# Access Compliance Report

## Public Rights-of-Way

Intersection ID: 44306	Main Street: MALLORY_TAYLOR_LN	Cross Street: LINDA_VISTA_LN	Location: NE
ADA ID: 70F7390F59E9	Ramp Type: PerpDiag	Initial Pass/Fail: Fail	Overall Compliance: No
Severity Score: 10			
Codes/Mitigation Info/Possible Solution		Field Measurements/Component Compliance

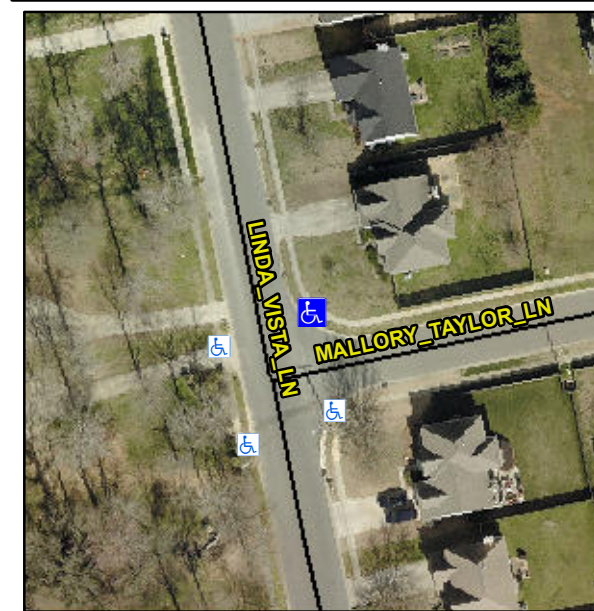
**Not Found, R304.5.1, R304.5.3**

Compliance	Description	Data	Compliance	Description	Data
N/A	Ramp Length (in)	49.5	Yes	Ramp Slope (%)	7.5
No	Ramp Width (in)	36.0	No	Ramp XSlope (%)	3.4
N/A	Flare Type LT	N/A	N/A	Flare Type RT	N/A
N/A	Flare Slope LT (%)	N/A	N/A	Flare Slope RT (%)	N/A
N/A	Flare Traversable LT?	N/A	N/A	Flare Traversable RT?	N/A
N/A	Landing Length (in)	N/A	N/A	DWS Provided?	N/A
N/A	Landing Width (in)	N/A	N/A	DWS Contrast?	N/A
N/A	Landing Slope (%)	N/A	N/A	DWS Length (in)	N/A
N/A	Landing X Slope (%)	N/A	N/A	DWS Full Width?	N/A
N/A	Landing Curb? (Y/N)	N/A	N/A	DWS Offset (in)	N/A
N/A	Shared Landing?	N/A			
N/A	Gutter Ponding?	N/A	N/A	Gutter Slope (%)	N/A
N/A	Gutter Lip Ht (in)	N/A	N/A	Gutter X Slope (%)	N/A
N/A	Painted X Walk1?	No	N/A	Painted X Walk2?	No
	X Walk 1 Direction	To W		X Walk 2 Direction	To S
N/A	X Walk 1 Width (in)	N/A	N/A	X Walk 2 Width (in)	N/A
	X Walk 1 Slope (%)	2.3		X Walk 2 Slope (%)	2.8
	X Walk 1 X Slope (%)	1.4		X Walk 2 X Slope (%)	2.8

**Remove & Replace Curb Ramp With Two New Directional Ramps or Equivalent.**
